Serial No. 10/714,935

Amendment Accompanying Request for Continued Examination

**AMENDMENTS TO THE DRAWINGS:**

FIG. 17 Conventional Art

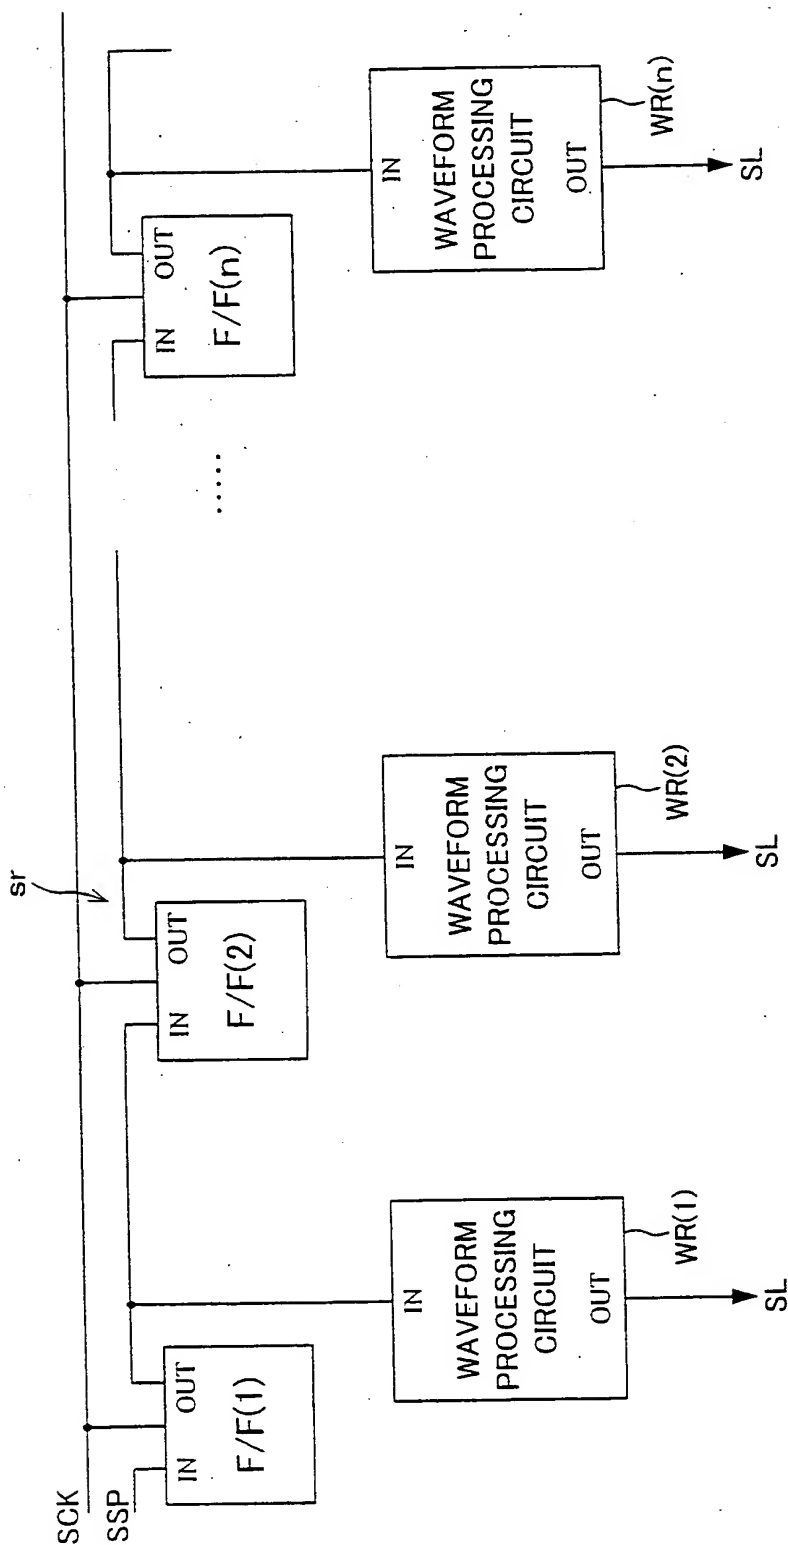
Figures 17-20 have been designated with the legend "Conventional Art". This legend is consistent with the description at, for example, page 19, line 18 et seq. No new matter has been added and the Examiner is invited to independently confirm that this is the case.

As required in the office action, Figures 17-20 have been designated with the legend "Conventional Art" based on the description at pages 19-20 of the specification, for example. Annotated Drawing Sheets Showing Changes and Replacement Drawing Sheets are included in the Appendix.
